# Product Change Notification

## 107357 - 00

**Change Title:** Intel® PRO/Wireless 3945ABG Network Connection Gen Skus: WM3945AGM1GEN, M2GEN, RWGEN, JPGEN, KRGEN, BGGEN, BGXGEN, (MM#s 872612, 872659, 874511, 874740, 874738, 874652, 878806), PCN 107357-00, Label, Add Regulatory Markings, OUI Replenishment

**Date of Publication:** March 05, 2007

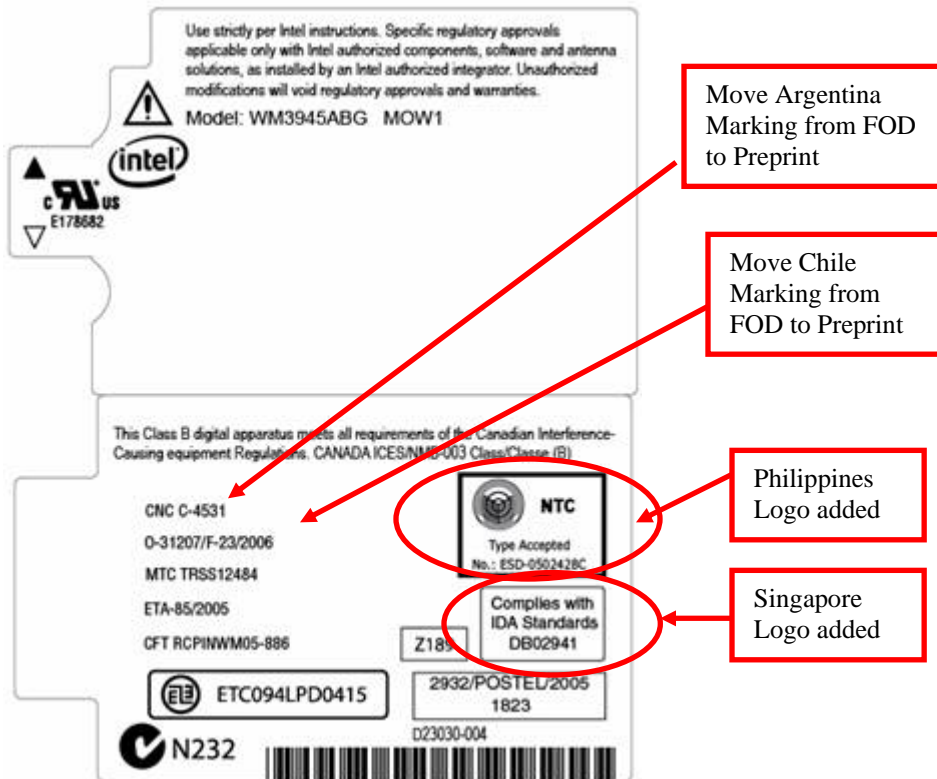
The following changes will be implemented during this ECO cycle:

1. Intel has depleted the available 3945ABG MAC addresses in the current OUI block. Allocation of MAC addresses in OUI 00-19-D2 will be exhausted by the end of WW14 (4/6/07). The change is required to continue to provide 3945ABG supply to Intel's customers. All Intel® PRO/Wireless 3945ABG Network Connection skus will be updated with the new OUI numbers.  
Description of change:  
Pre-Conversion: 00-19-D2  
Post-Conversion: 00-1B-77
2. Regulatory marking changes on the M1GEN product label
  - Add Regulatory Markings for Philippines and Singapore
  - Move the Chile and Argentina regulatory markings from FOD print to Pre-print label.

1. New MAC addresses with a change in the first 6 characters.  
Pre-Conversion: 00-19-D2  
Post-Conversion: 00-1B-77
2. Regulatory marking changes for M1GEN product label  
New M1GEN

3. Dash to the TA#
